MIL-M-28787/171A(SH)
AMENDMENT 1
29 March 1991

MODULES, STANDARD ELECTRONIC

GATE, EXCLUSIVE OR, DIGITAL, KEY CODE EBB

FIGURE 5 V_{OUT} (low-loaded) test circuit for table III

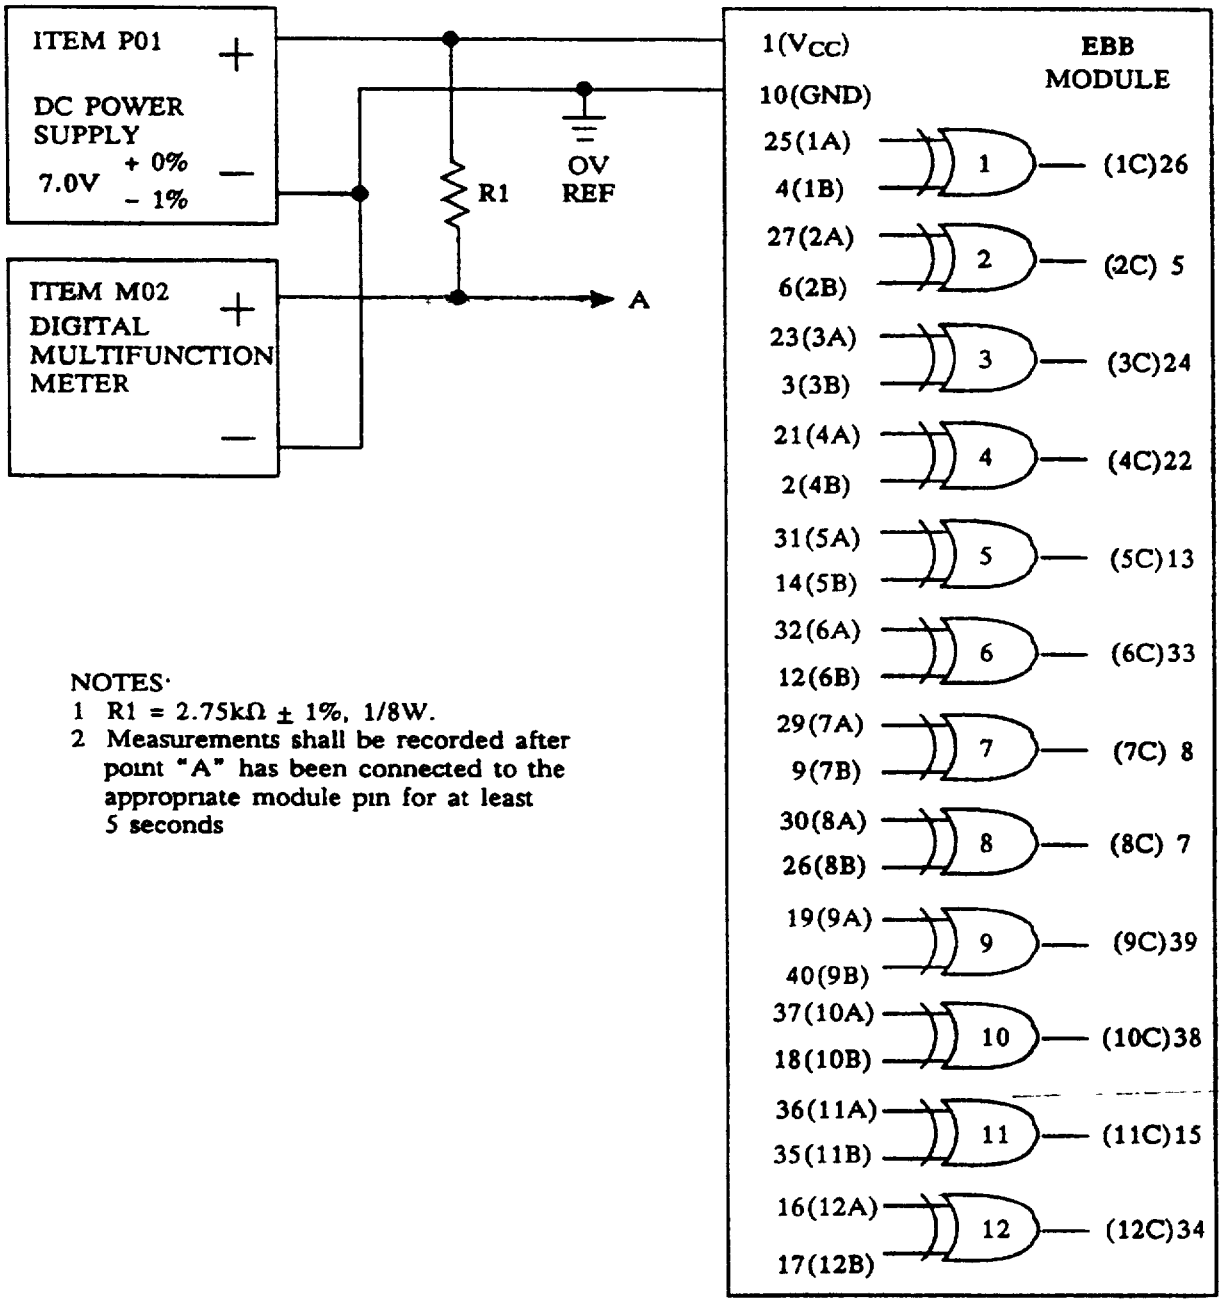
FIGURE 5. Delete and substitute new figure 5 as printed on page 3 of this amendment

NOTES:
1. R1 = 2.75kΩ ± 1%, 1/8W.
2. Measurements shall be recorded after point "A" has been connected to the appropriate module pin for at least 5 seconds

FIGURE 8 Static output voltage (low-level and high-level) test circuit for tables VI and VII

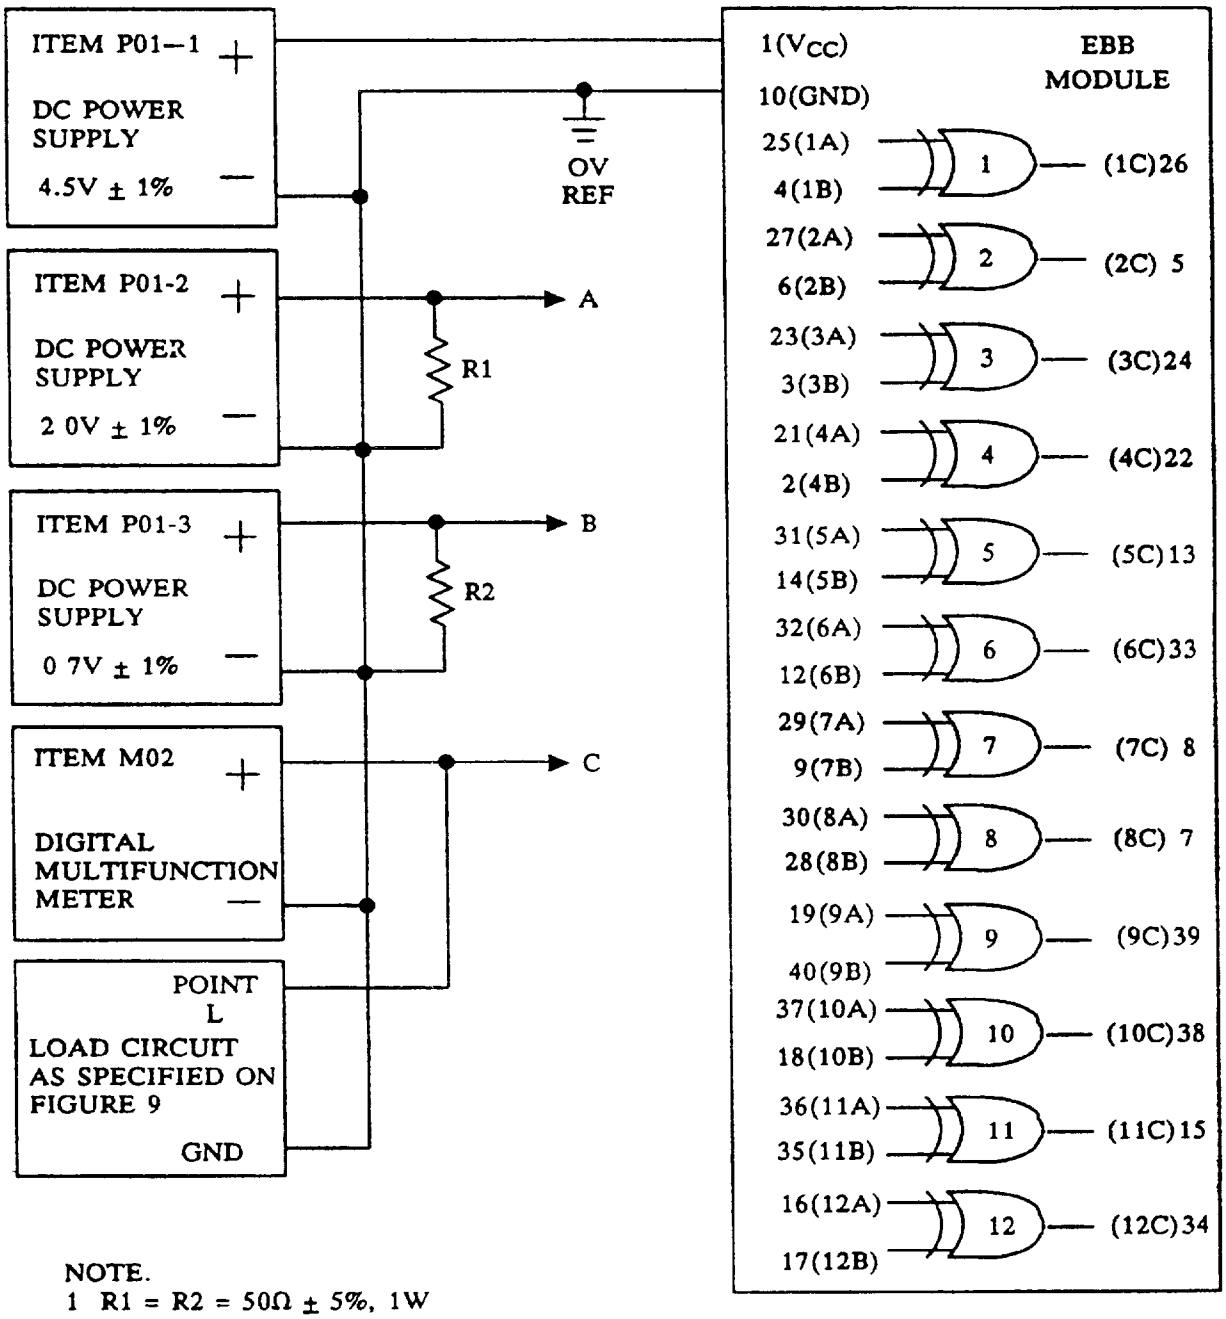
FIGURE 8. Delete and substitute new figure 8 as printed on page 4 of this amendment

NOTE.
1 R1 = R2 = 50Ω ± 5%, 1W
